Axcelerator Family FPGAs Errata

Some errors were found in the Axcelerator data sheet. The corrections, noted below, will be incorporated into a revised version of the data sheet. The changes in the graphics are indicated in red font. Within the body, corrections are in bold.

Page 16

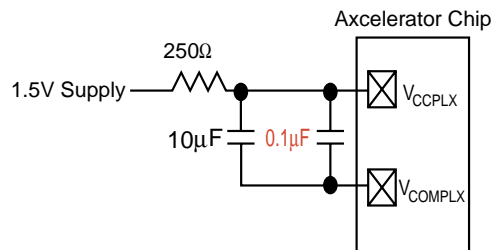
- In the figure, the value for the capacitor on the right is incorrectly shown as 100 μ F. The correct value is **0.1 μ F**.

Page 70

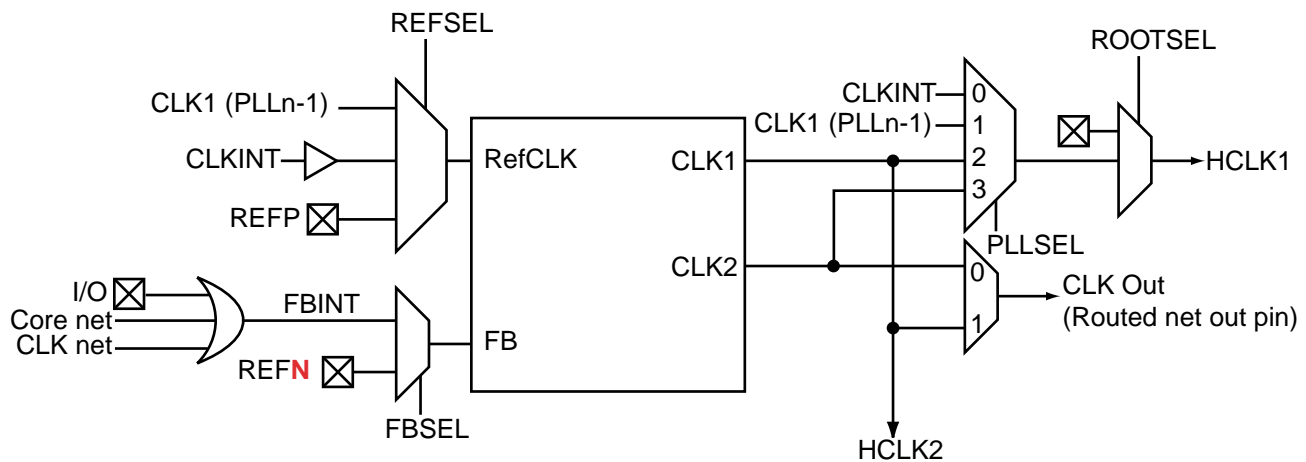
2. In the interface block diagram one of the signals is shown incorrectly as REFD. It should be **REFN**.

Page 75

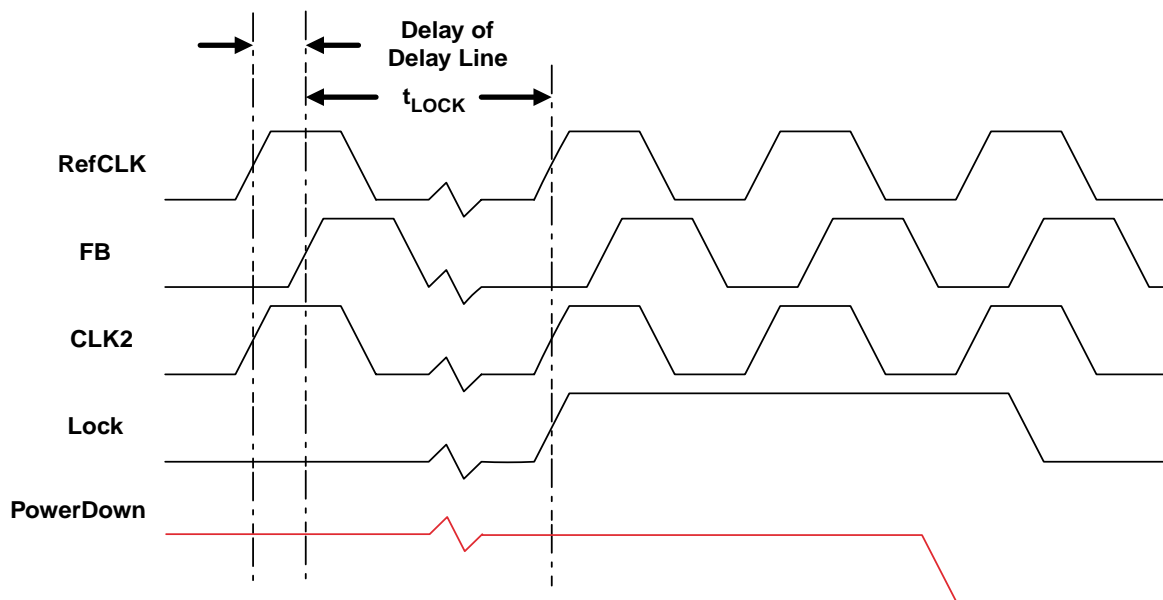
2. In the timing waveform diagram, the PowerDown signal is drawn incorrectly. The figure below shows how it should appear.
